CONSTRUCTION SUMMARY

Grovetrail Developments Inc.

LOT NUMBER	PHASE	HOUSE TYPE	CLOSING DATE
63 BLOCK 234	3	MACKENZIE END-OPT 2ND LEVEL-ELEV B	05-Aug-25

Lot: 63 BLOCK 234 Project: Grovetrail Developments Inc. Model: MACKENZIE END-OPT 2ND LEVEL-ELEV B

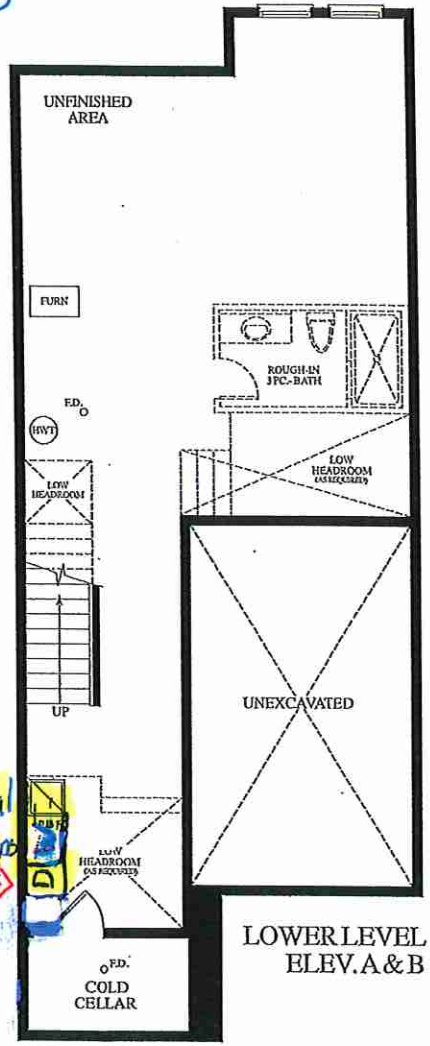
1 - BASEMENT - Install ADDITIONAL LAUNDRY ROUGH-INS ONLY (Inlcudes Electricalfor Washer and Dryer) To be installed beside existing standard laundry tub at basement (See Sketch) Note:

Additional
curbway rough-in

BLK. 234 TH 63 20-09 THE MACKENZIE EL. B 1710 SQ. FT.

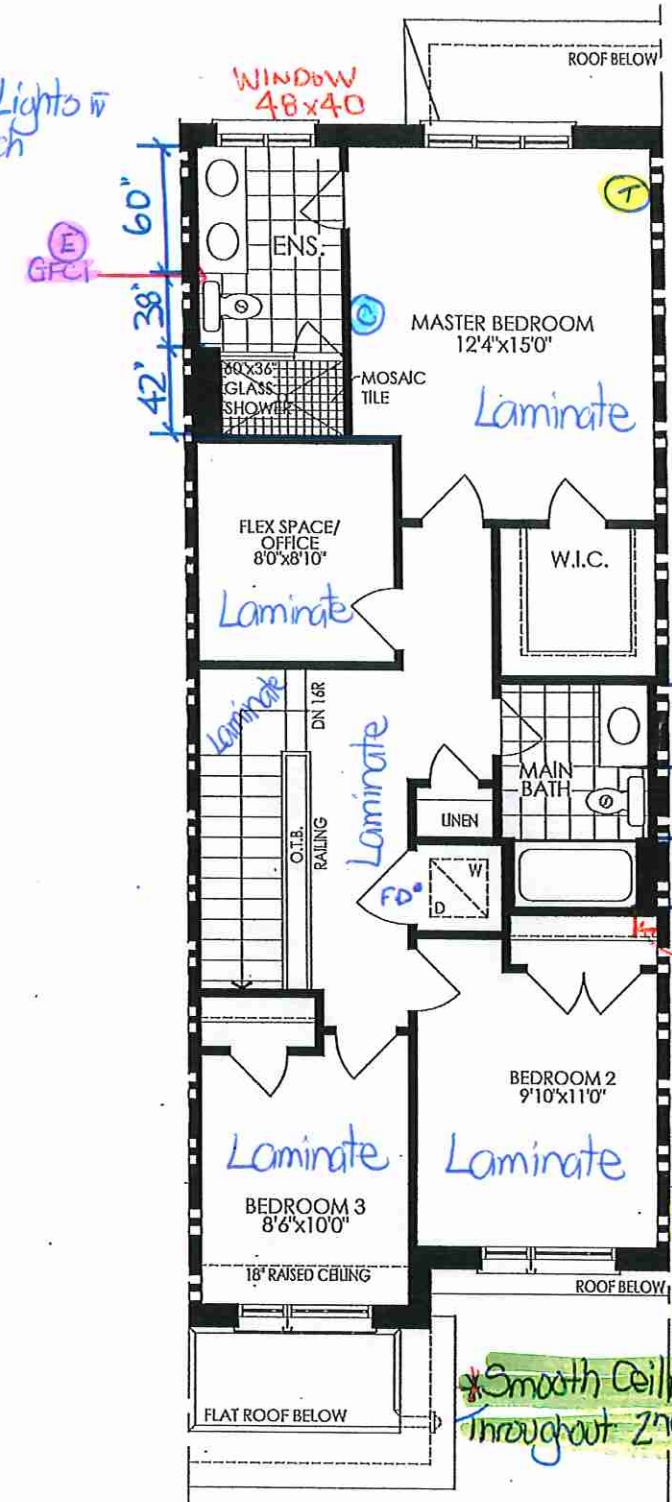
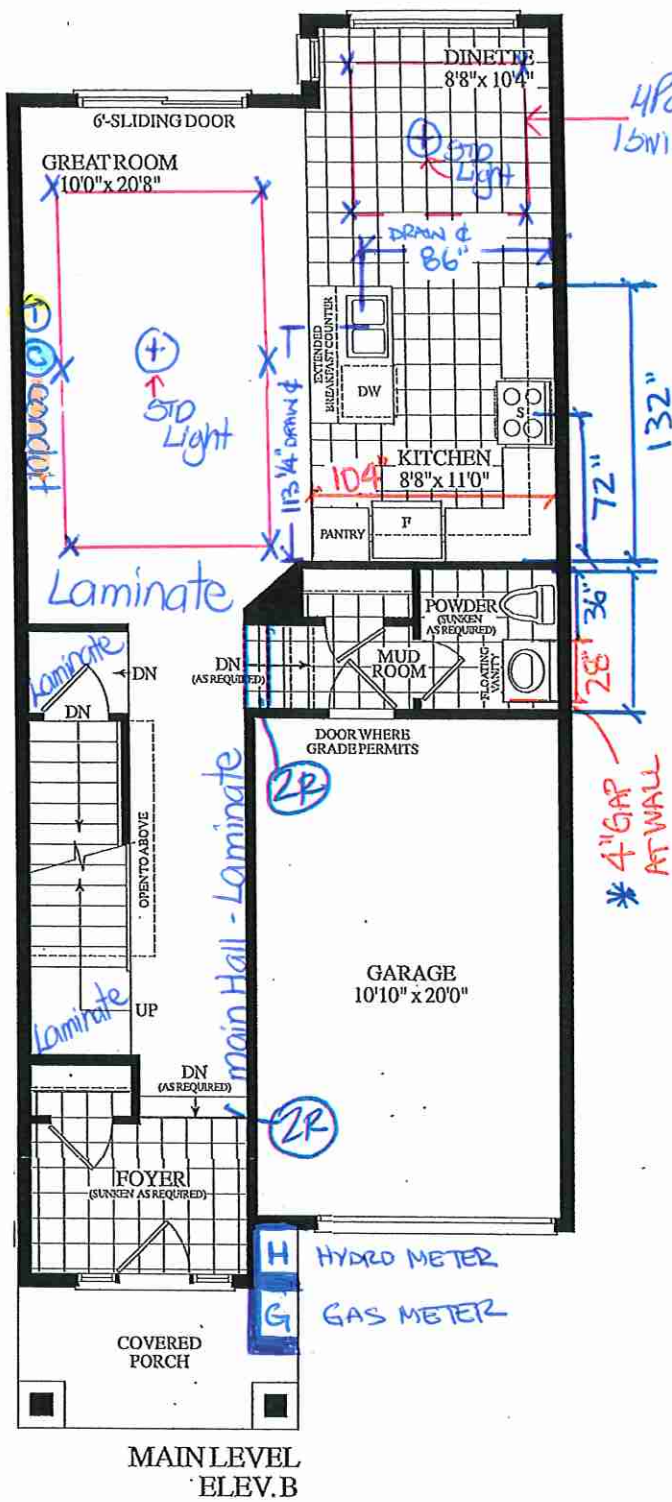
I - SECOND FLOOR - CEILINGS - Install UPGRADE SMOOTH CEILINGS Throughout 2nd Floor, where applicable. To Include: Upper Hall, Master Bedroom, Bedroom #2, Bedroom #3 and Flex Space/Office. (See Sketch) Note:
I - BONUS PACKAGE - PURCHASER HAS APPLIED \$7,500.00 (Includes Taxes) WORTH OF UPGRADE PROMOTIONAL PACKAGE TOWARDS THE PURCHASE OF STRUCTURAL UPGRADES COMPLETED AT THE DECOR CENTRE Note:
I - PURCHASER HAS ATTENDED A STRUCTURAL APPOINTMENT AT THE DESIGN STUDIO & HAS DECLINED ANY ADDITIONAL UPGRADES. Purchaser accepts & acknowledges that there will be no further structural changes/additions/deletions to be made upon signing on JANUARY 29,2025 Note:
I - PURCHASER AWARE AND ACCEPTS THAT ANY CHANGES MADE TO UPGRADES AFTER SIGNING THIS PURCHASERS EXTRA FORM ARE SUBJECT TO A MINIMUM ADMINISTRATION FEE OF \$1,000 Note:

Smooth Ceilings
throughout 2nd Floor

KITCHEN ELEVATION

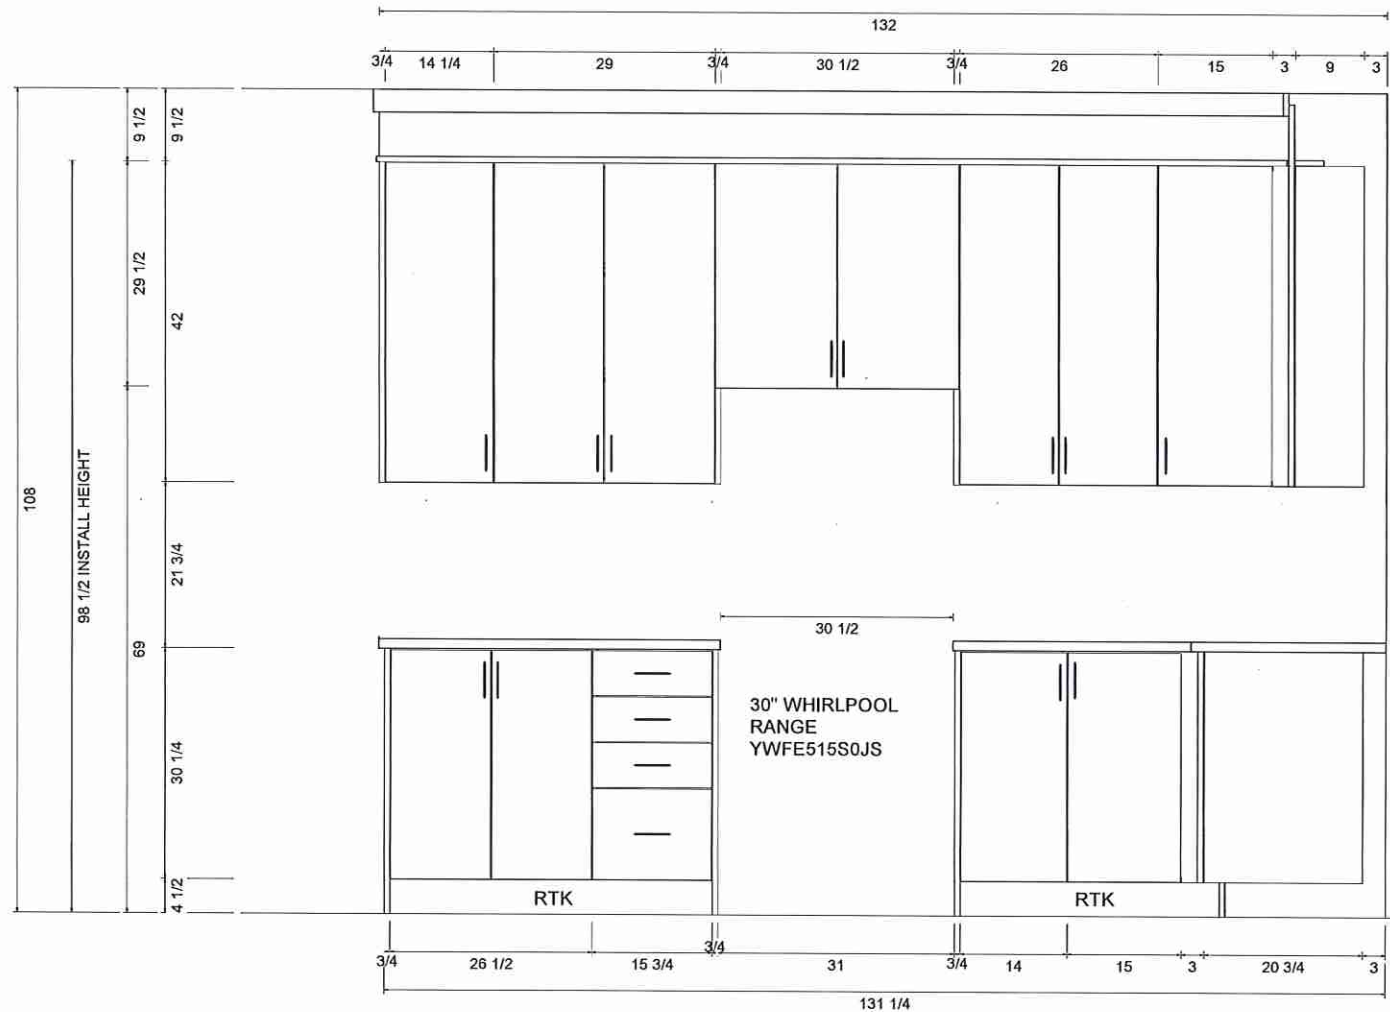
1 - KITCHEN - CABINETRY - Install UPGRADE EXTENDED HEIGHT UPPER CABINETRY WITH LARGE CROWN MOULDING Includes FASCIA & PAN - To be installed throughout upper kitchen cabinetry, where applicable. Upper Cabinetry to Extend Up to Touch Ceiling.(See Sketch) Note: Priced as per Villa
1 - KITCHEN - COUNTERTOP - Install Builders Standard Stone Countertop – EVEREST VANILLA WHITE with STANDARD " A " EDGE PROFILE - To be installed throughout kitchen, where applicable (does not include stone backsplash) (See Sketch) Note:
1 - DISCLAIMER - STONE COUNTERTOP; KITCHEN - Due to the many variables that can affect the pattern, colour and/or design and “pitting” of stone products, stone installed will not be identical to the samples displayed. Note: Every effort is made to provide stone countertops as close as possible but the vendor is not responsible for results which differ from the sample displayed. All countertop surfaces may have seams, and product pattern and shade can change in areas containing seams.
